**HORIZONTAL DIRECTIONAL DRILL ANALYSIS
YELLOW BREECHES CREEK CROSSING
PADEP SECTION 105 PERMIT NO.S: E21-449
PA-CU-0203.0000-WX & PA-CU-0203.0000-WX-16
(SPLP HDD No. S2-0250)**

This reanalysis of the horizontal directional drill (HDD) installation of a 16-inch and 20-inch diameter pipeline crossing under Yellow Breeches Creek, is in accordance with Stipulated Order issued under Environmental Hearing Board Docket No. 2017-009-L for HDDs listed on Exhibit 2 of the Stipulated Order. This HDD is number 14 on the list of HDDs included on Exhibit 2. This HDD was not initiated before the issuance of the Order.

ATTACHMENT 2

ORIGINAL AND REVISED HORIZONTAL DIRECTIONAL DRILL PLAN AND PROFILES

SCALE: 1"=200' DWG. NO: PA-CU-0203.0000-WX-16

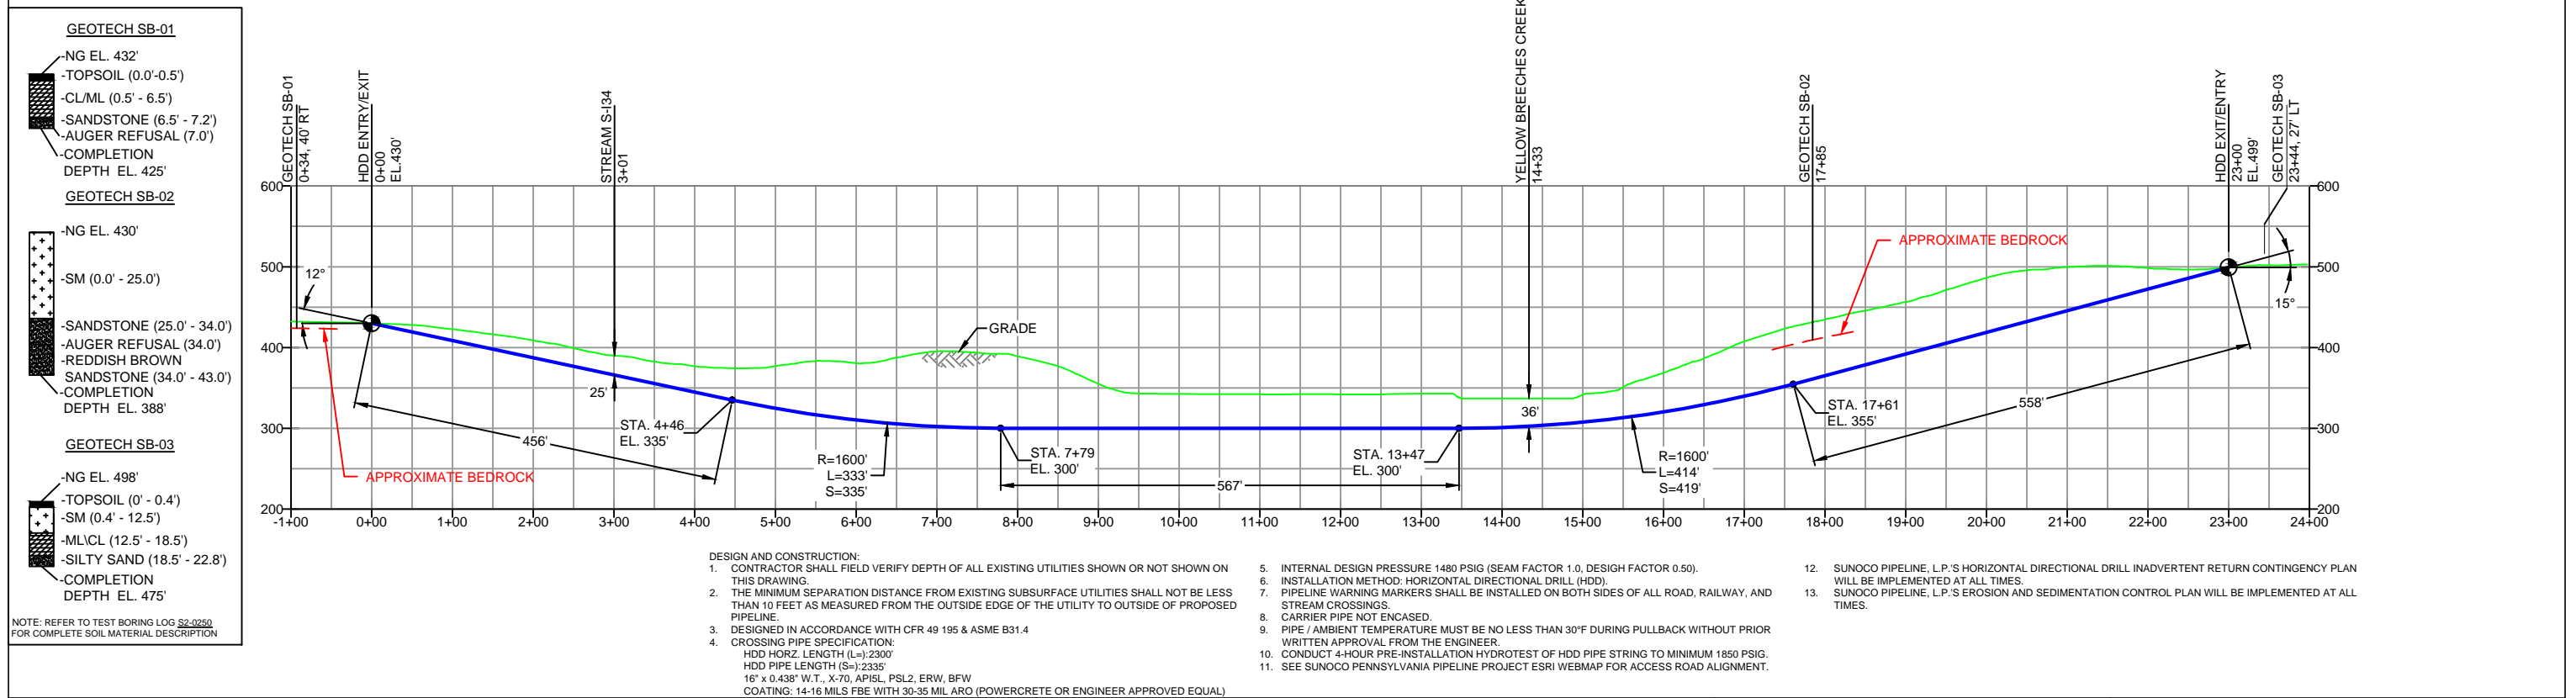
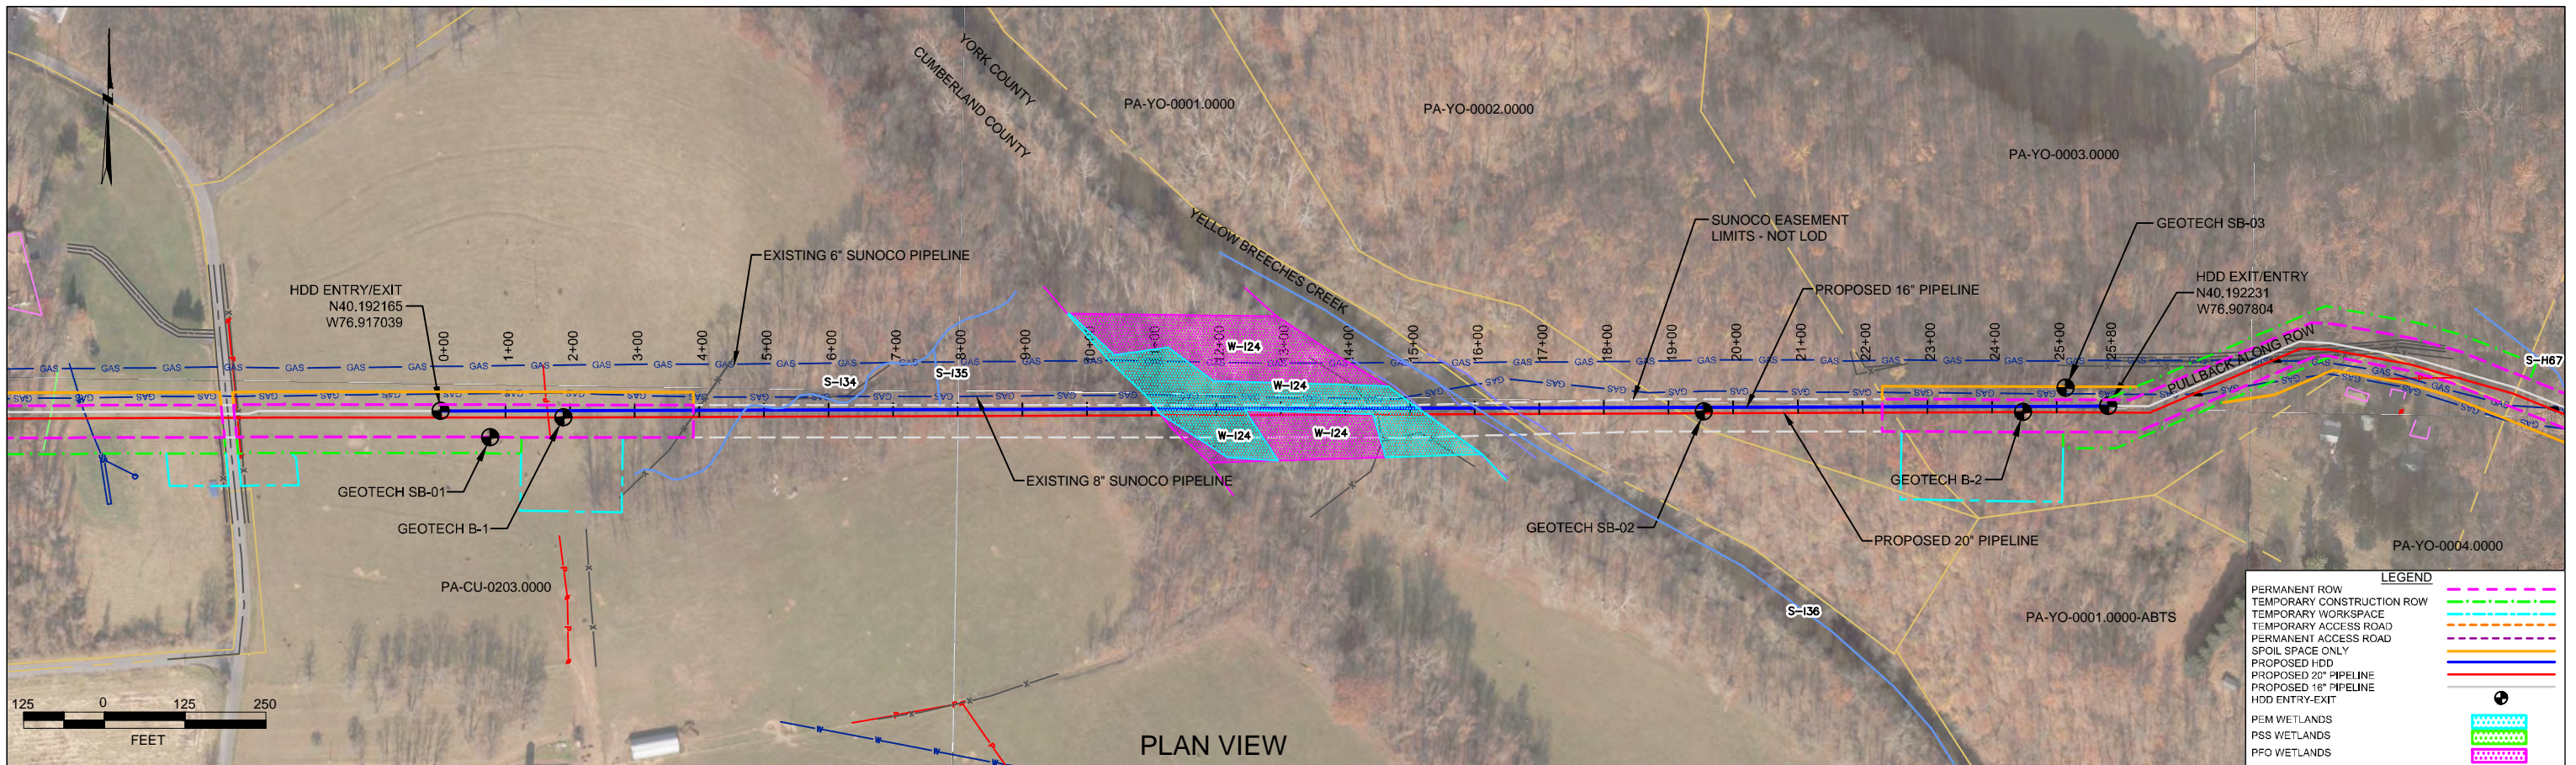
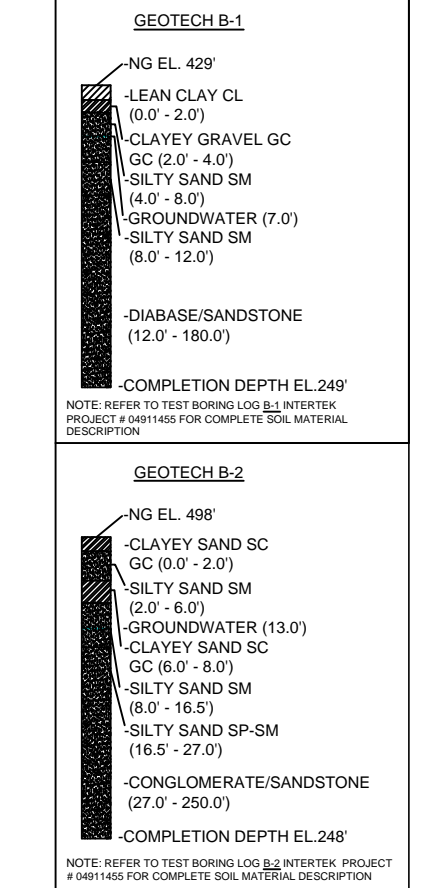
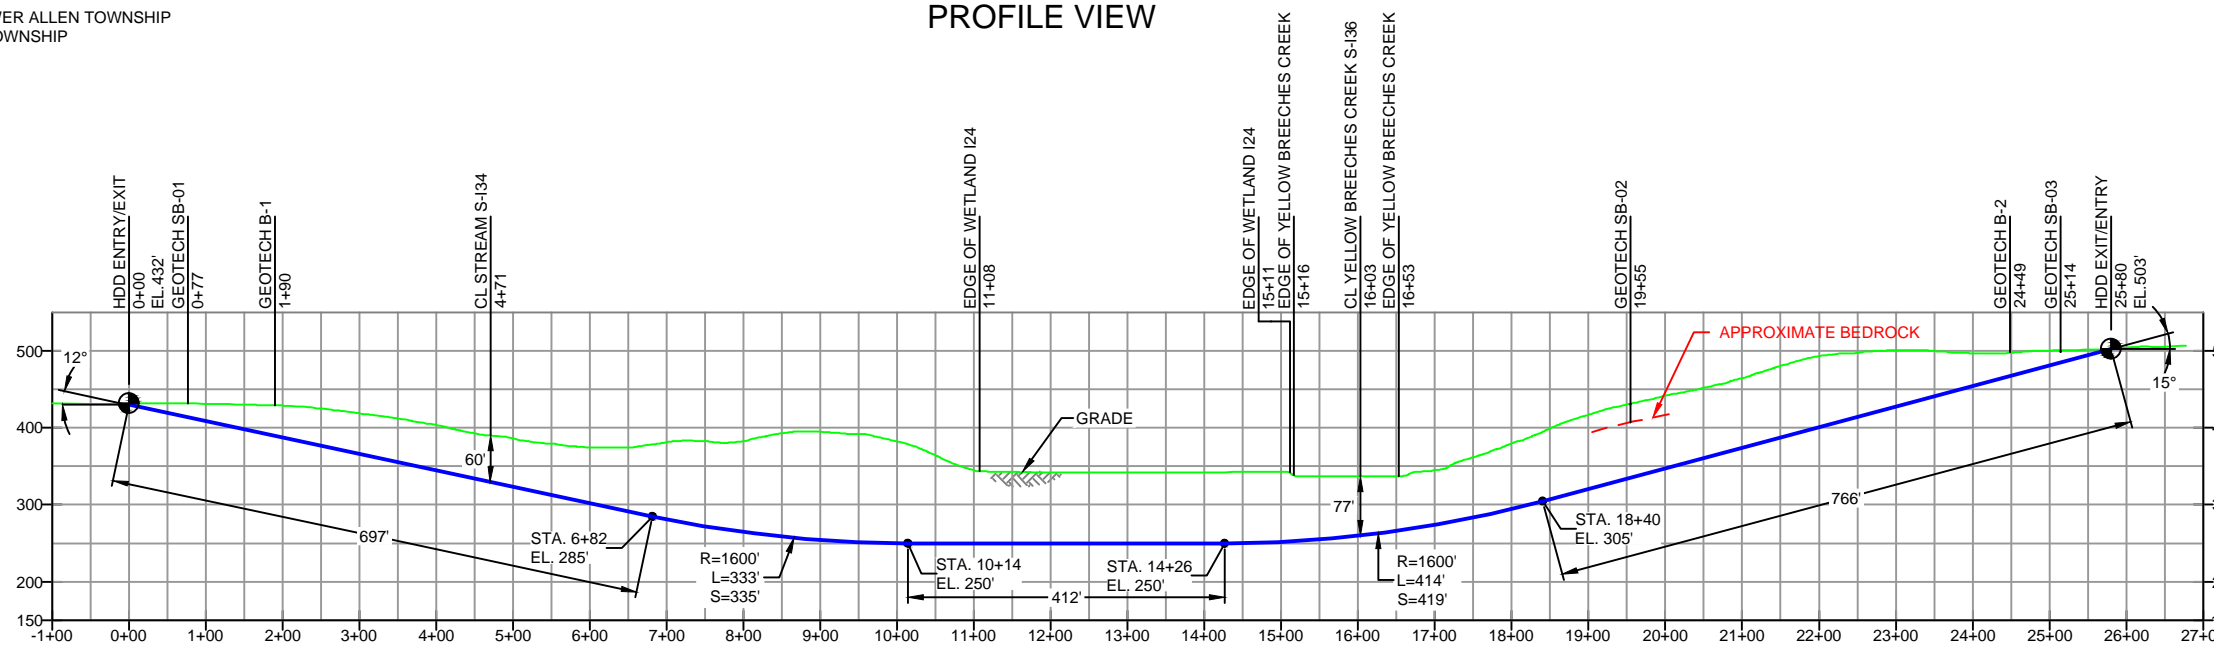
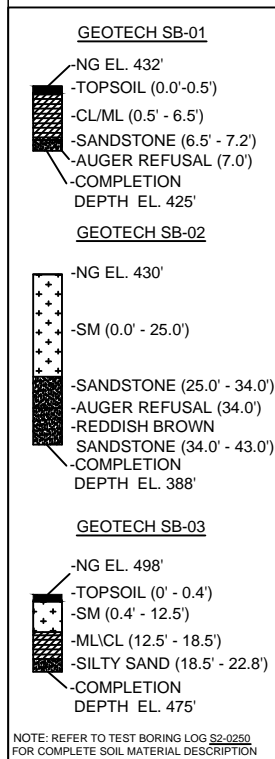
SPLP HDD consultants reviewed the HDD designs and geotechnical data for this area. Based upon this review, it was determined that the risk of IRs to waters overlying the HDD could be reduced by increasing the depth of the original permitted HDD profile. Additional geologic investigations have been completed and utilized in the redesign of the planned HDD. The redesign adjusts the HDD profile deeper to place the HDD pathway through bedrock having better structural integrity than a shallower profile and increase the overall length of the HDD due to pipe design requirements. A summary of the redesign factors is provided below.

REVISED HORIZONTAL DIRECTIONAL DRILL DESIGN SUMMARY: 16-INCH

- Horizontal length: 2,580 foot (ft)
- Entry/Exit angle: 12-15 degrees
- Maximum Depth of cover: 94 ft
- Depth under Yellow Breeches Creek: 77 ft
- Depth under wetland W-124: 87 ft
- Depth below Stream S-134: 60 ft
- Pipe design radius: 1,600 ft

It is SPLP’s intent to modify the original profile design and to pursue a deeper and longer HDD profile. Figures 1 and 3 in Attachment 2 presents the original HDD plan and profiles. Figures 2 and 4 presents the revised HDD plan and profiles.
